ADDENDUM 1

2017-020

INFRASTRUCTURE AND WIFI

Questions/Clarifications

Additional information:

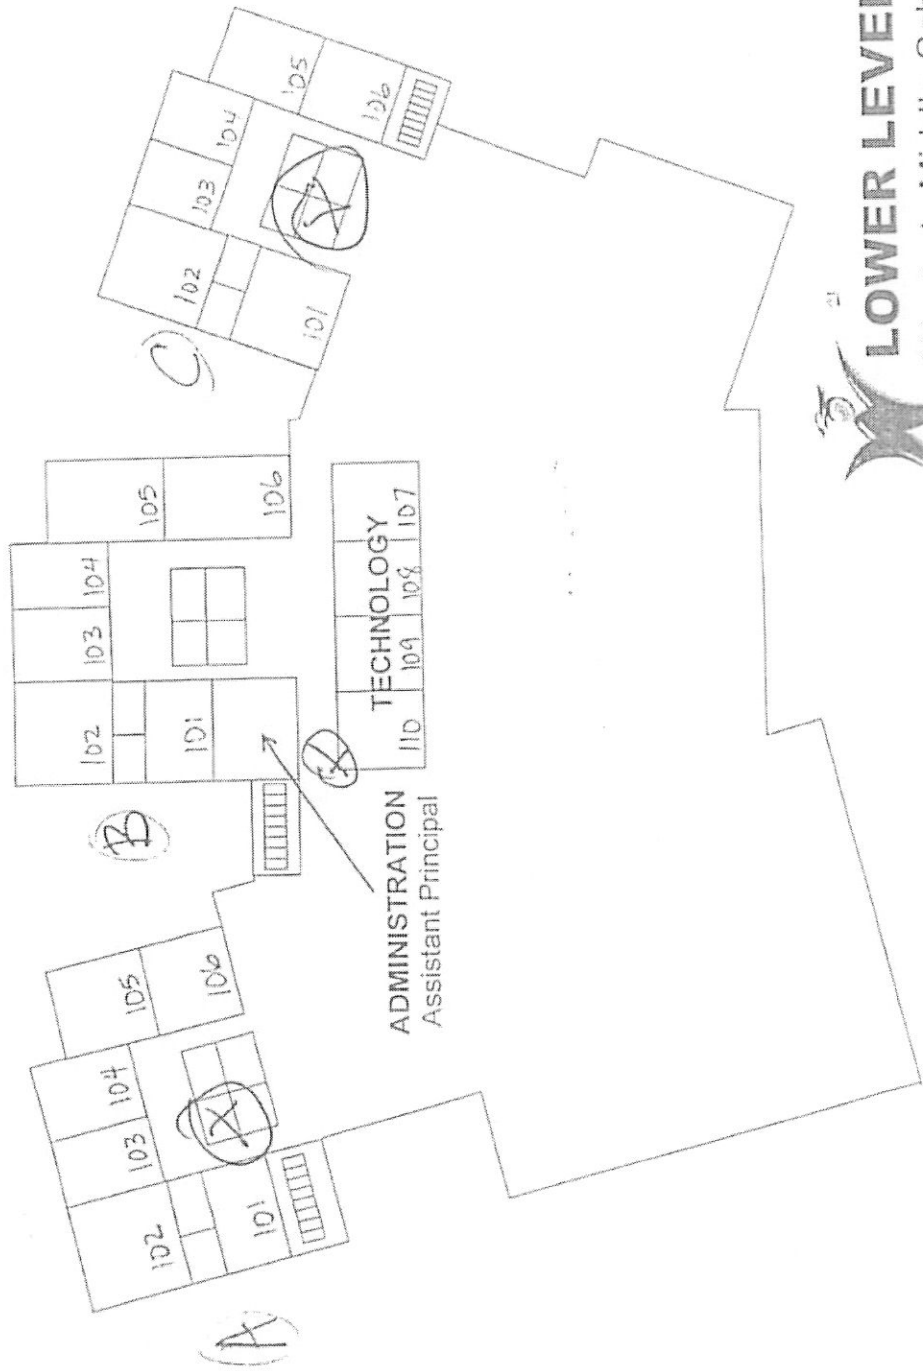
6. We will wave this requirement. 1 GBPS is sufficient.

19. Only Basic compatibility. Waved.

21. It will need to support 1000, so controller quoted should reflect scalability, i.e. 7220.

24. We will wave this since E-Rate won't support.

25e. No additional costs or software required, so will wave this.
